TECHNICAL ARTICLE
TA-LIF-010

9A CONTROL VALVE AND COIL DESIGN UPDATE

PARKER GOLD CUP SERIES

Document no: TA-LIF-010
Product: Parker Gold Cup
Author: Andres Sabino
Date: 11/05/2026
Department: Engineering

Figure 3: New 9A Valve does not have an o-ring seal

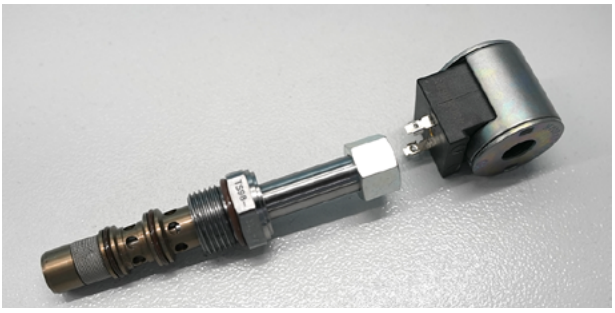
The new valve does not have an o-ring seal, although they look very similar. See figure 3 below.

Figure 5: Nut comparison

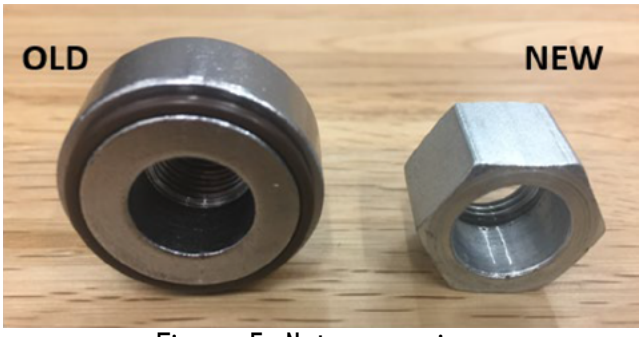
A very obvious difference between the old and new coil is the nut used to tighten it. The old round nut appears to be much larger than the new nut, but it does take the same 3/4” wrench size. Torque to 20-25 in-lbs.

Figure 6: The right and wrong way to place the coil

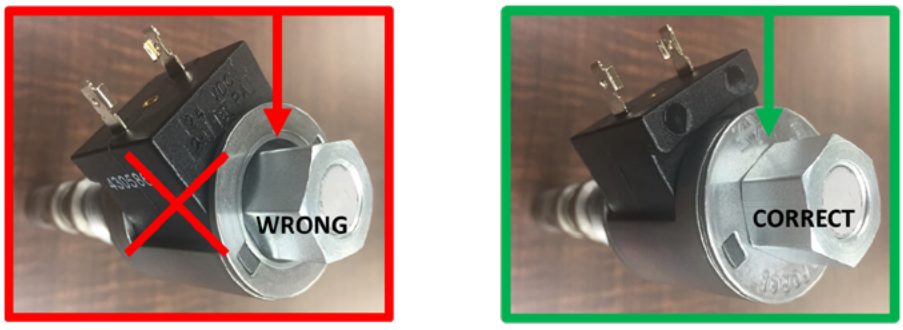
The coil can be installed upside down which will cause the pump to not get full flow. The solid metal face of the coil should be facing the coil nut. See figure 6 below.
